Northchurch, Berko, – Location Report

New Road **Rejected**

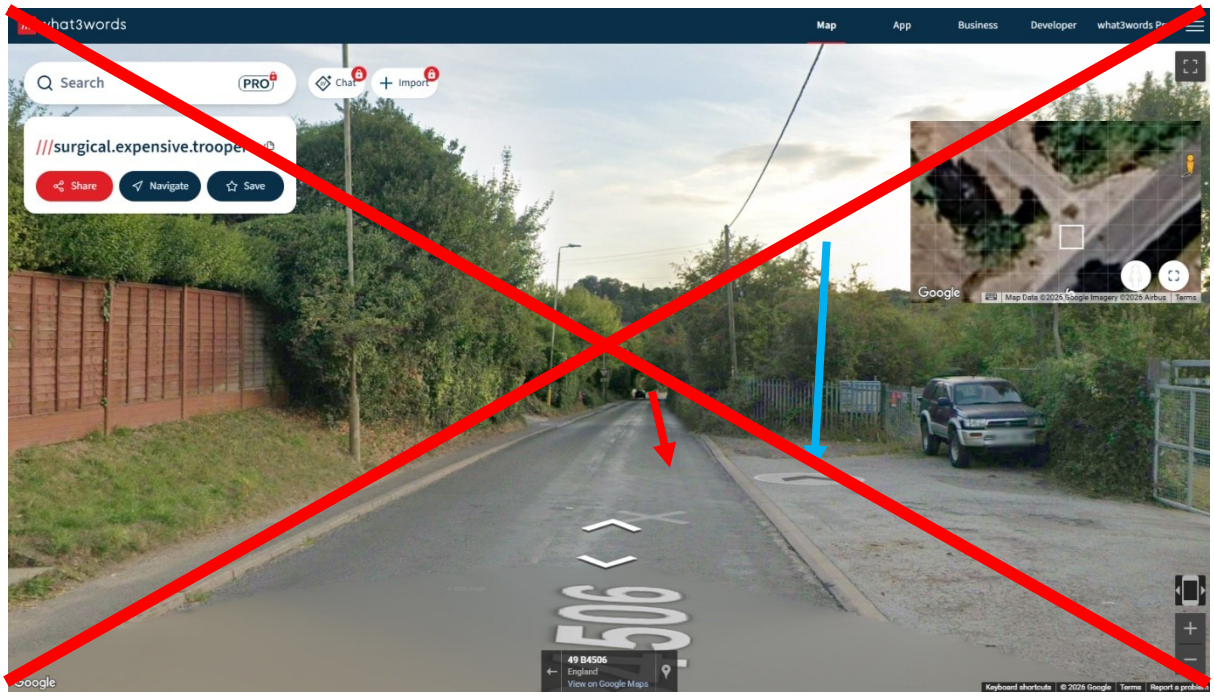
The entrance to Northchurch upper allotments and Sunnyside Rural Trust – Location visibility insufficient to allow SID sign to detect approaching vehicles travelling northeast along New Road. This is due to heave vegetation along the edge of the roadway with no footpath. The entrance to the allotments is not suitable for the volunteers or equipment to be housed safely and will cause an obstruction to road users view of adjoining and leaving the allotments.

New Road Rejected

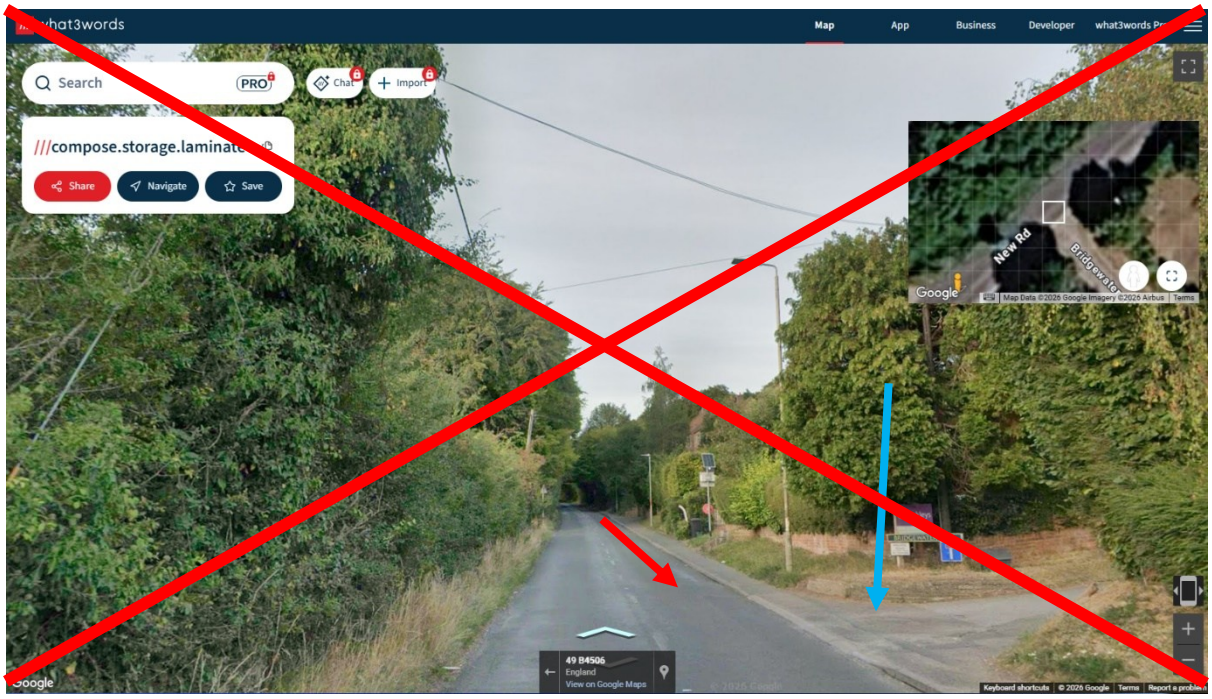
The junction of Bridgewater Hill – Location visibility sufficient to allow SID sign to detect approaching vehicles travelling southwest down New Road. However, there is a fixed SID sign approximately 50yrds away from the location and could cause conflicting readings between the two SIDs. This location is also within the 161 mts away from the 40mph zone and will pick up vehicles outside of the 30mph zone. This location will also not allow road users an unobstructed view of adjoining New Road from Bridgewater Hill. The footway is not sufficiently wide enough to provide a minimum of 1.0 mtr clear and unobstructed footway width.
